Technical Specification

Page Revisions

Consolidated Edison Company of New York, Inc.  
Indian Point Unit No. 2  
Docket No. 50-247  
March, 1982

### Safety Evaluation

Figure 3.3-1 Boron Injection Tank Required Pressure vs Liquid Volume

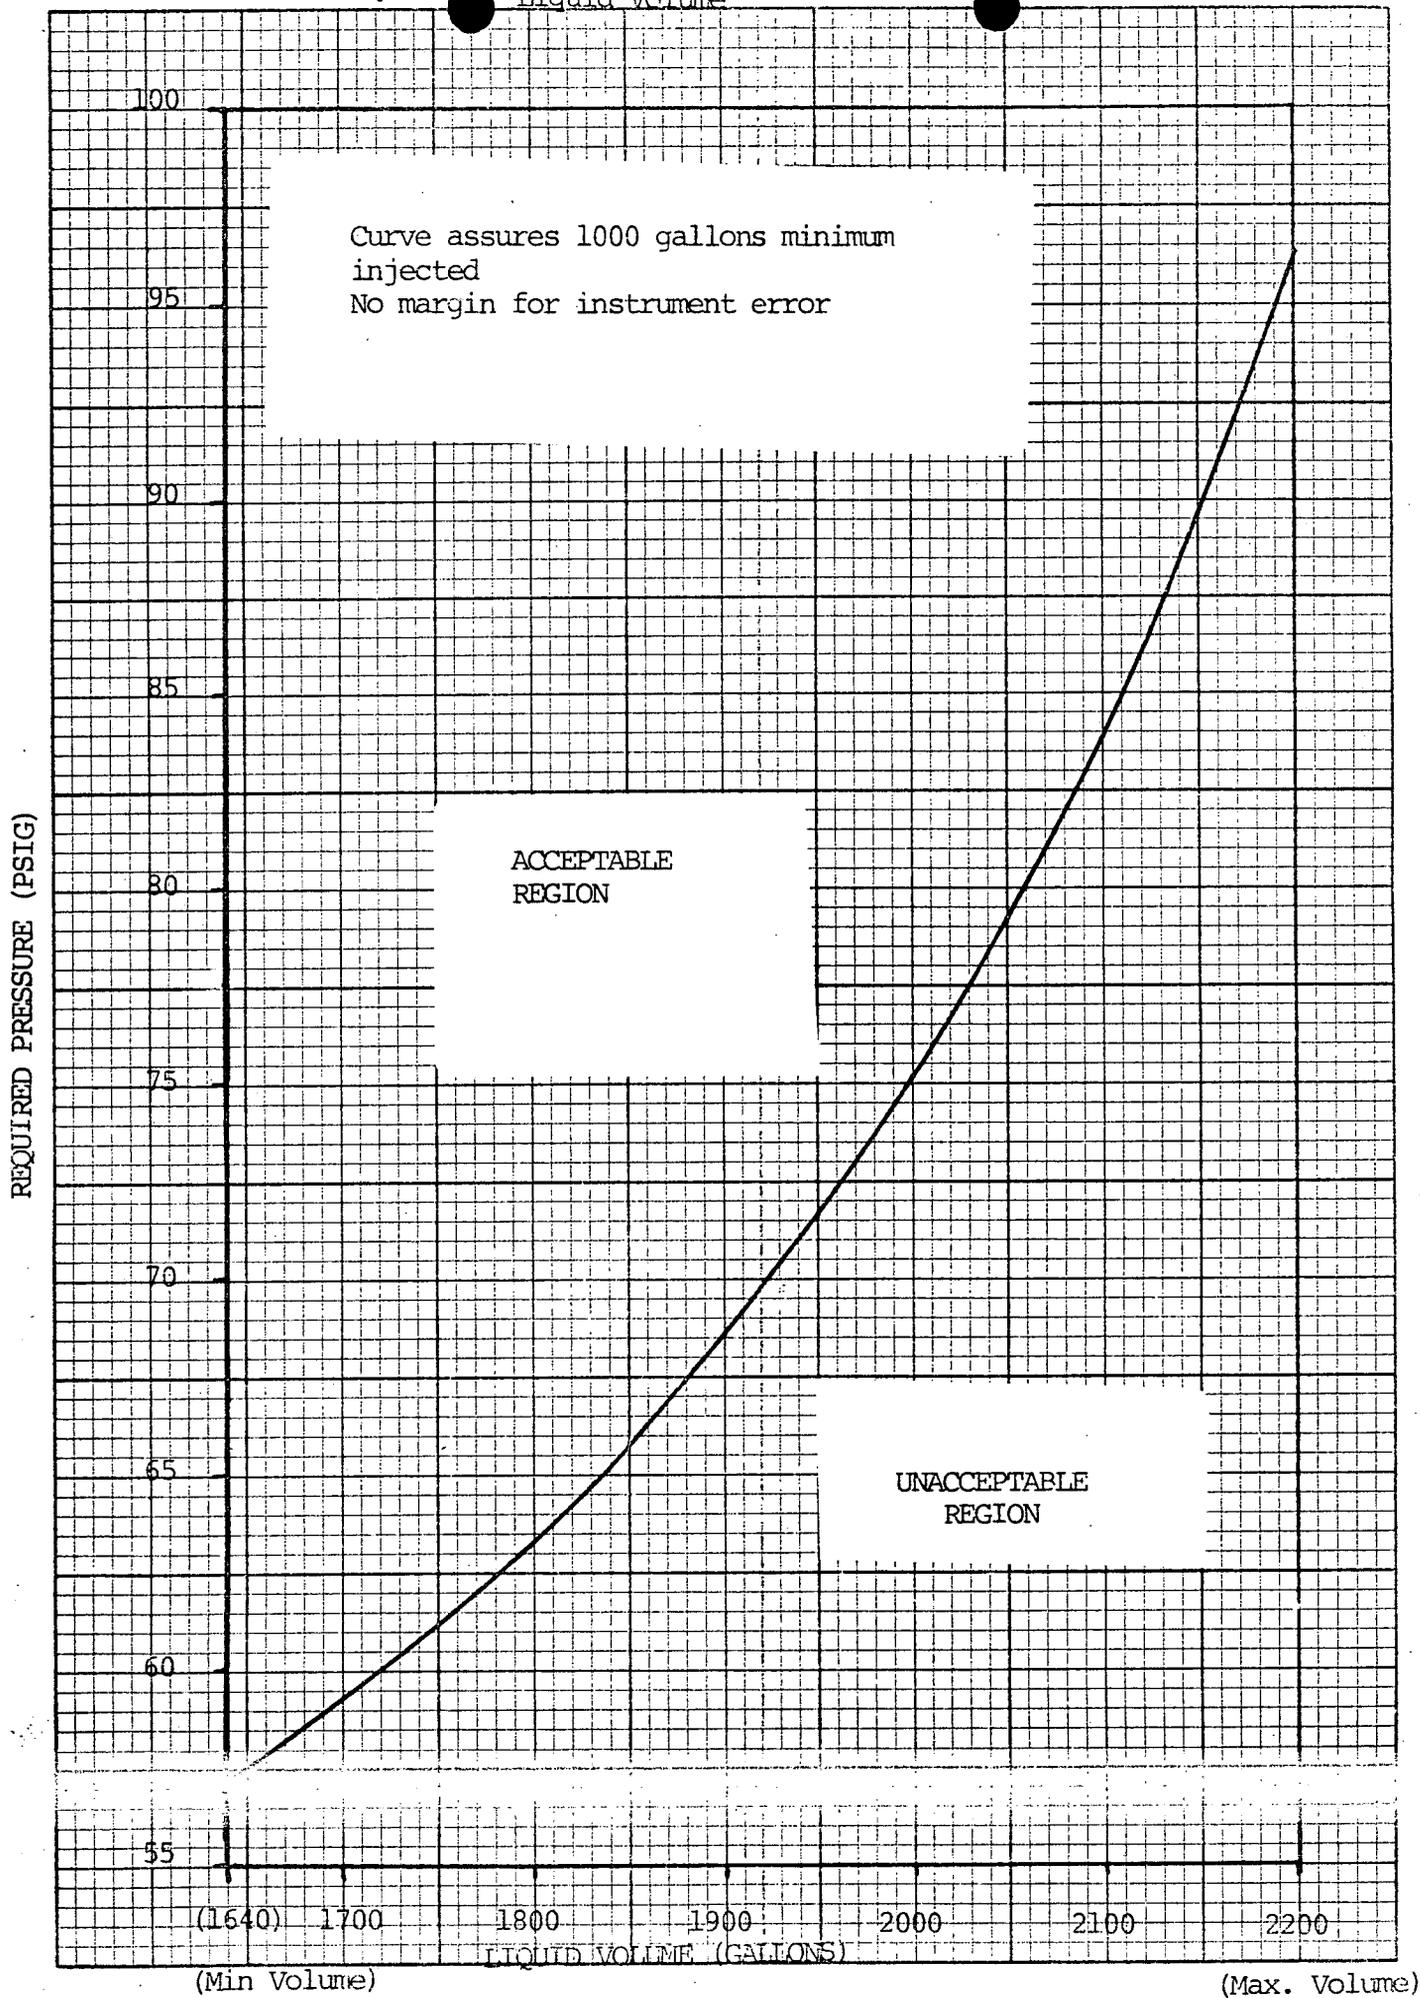
- b. The boron injection tank liquid volume and pressure are in the acceptable region of Figure 3.3-1 with a 11 1/2% to 13% by weight (20,000 ppm to 22,500 ppm of boron) boric acid solution at a temperature of at least 145°F. Two channels of heat tracing shall be available for the flow path. Valves 1821 and 1831 shall be open and valves 1822A and 1822B shall be closed, except during short periods of time when they can be cycled to demonstrate their operability. Three channels of level instrumentation for automatic tank isolation are available in the untripped mode and set to initiate isolation with between 440 gallons and 640 gallons remaining in the tank.

The proposed changes, contained in Attachment A to this Application, would revise the technical specifications to clarify the minimum conditions required for operability of the boron injection tank (BIT). Specifically, the single minimum required liquid volume would be replaced by a curve which would establish a pressure/liquid volume relationship for determining BIT operability. In addition, specific limiting conditions for operation (LCOs) and surveillance requirements would be established for BIT parameters and required instrumentation channels. The requested changes are the result of Con Edison's followup review of the Reportable Occurrence reported as LER-82-009/01T-0.

The limit on boron injection tank minimum pressure ensures that sufficient driving head is available to inject the required amount of borated water into the reactor coolant system. The limits on boron injection tank volume, boron concentration and low level tank isolation assure that the assumptions used in the steam line rupture analysis are met. The limiting boron injection tank pressure/volume relationship depicted in Figure 3.3-1 does not include instrumentation errors which should be considered in determining compliance with this specification.
